KIRKLAND ESTATES

RESUBDIVISION OF LOT 2

APPLICATION NUMBER 9 DATE October 2, 2008

APPLICANT Kirkland Estates Subdivision, Resubdivision of Lot 2

**KIRKLAND ESTATES SUBDIVISION,
RESUBDIVISION OF LOT 2**

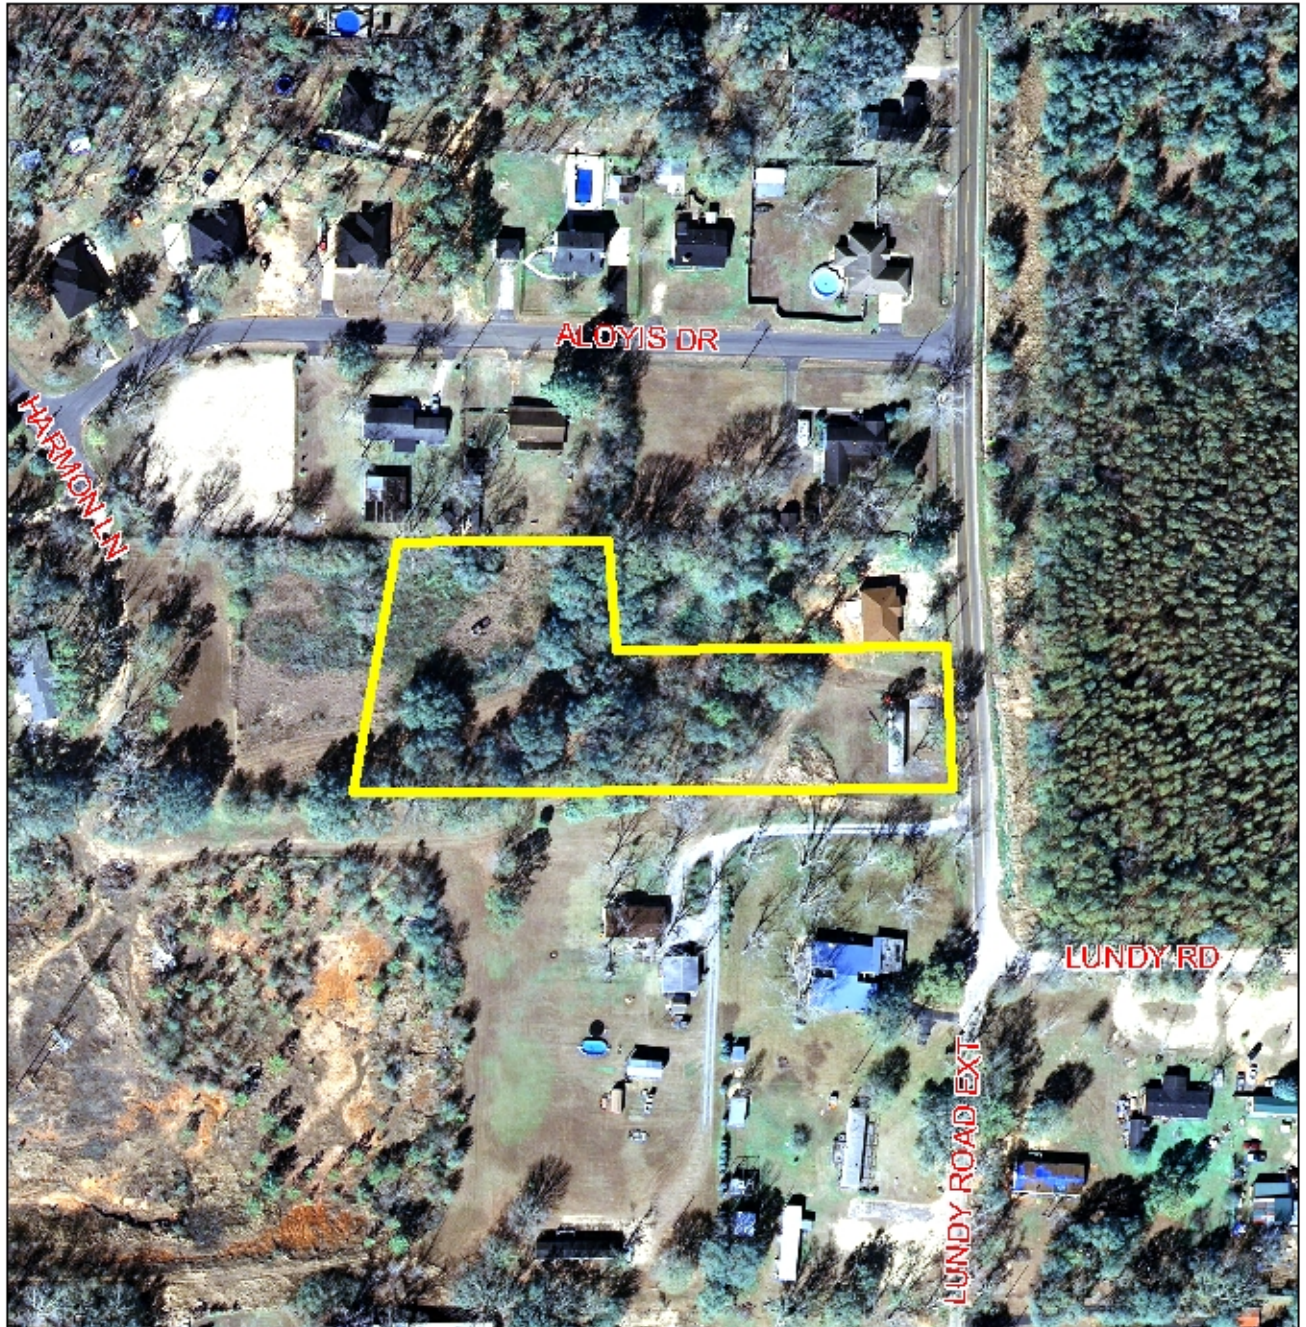
The site fronts Lundy Road, a minor street with 50' of right-of-way. Section V.B.14. of the Subdivision Regulations requires that minor streets without curb gutter have a minimum 60' right-of-way. Therefore, the plat should be revised to dedicate sufficient right-of-way to provide a minimum 30' as measured from the centerline of Lundy Road.

As proposed, Lot A has approximately 100' of frontage along Lundy Road and should be limited to one curb cut. Lot B is a flag lot with approximately 30' of frontage. The subject site (Lot 2 Kirkland Estates) currently has a flag lot orientation approved in 2005, at which time the Planning Commission waived Section V.D.1. of the Subdivision Regulations. The regulations have since been amended to allow flag lots under certain conditions, one being for the family subdivision of property, which is the purpose of this application as stated in a letter submitted by the applicant. If approved, Lot B should be limited to one curb cut, and a note should be placed on the final plat stating that no future subdivision is allowed unless additional adequate frontage on a public street is provided.

Section V.D.1. also requires lots to be 60' wide at the building setback line. It is recommended that the minimum building setback line should be revised on Lot B to provide 25' from where the “pole” meets the “flag” portion of the lot.

- 1) placement of a note stating that each lot is limited to one curb cut to Lundy Road, with the size, location, and design to be approved by County Engineering and conform to AASHTO standards;

- 2) placement of a note on the final plat stating that no future subdivision of Lot B is allowed unless additional adequate frontage on a public street is provided;

- 3) revision of the minimum building setback line on Lot B to provide 25' from where the "pole" meets the "flag" portion of the lot;
- 4) the applicant receive the approval of all applicable federal, state, and local environmental agencies prior to the issuance of any permits;
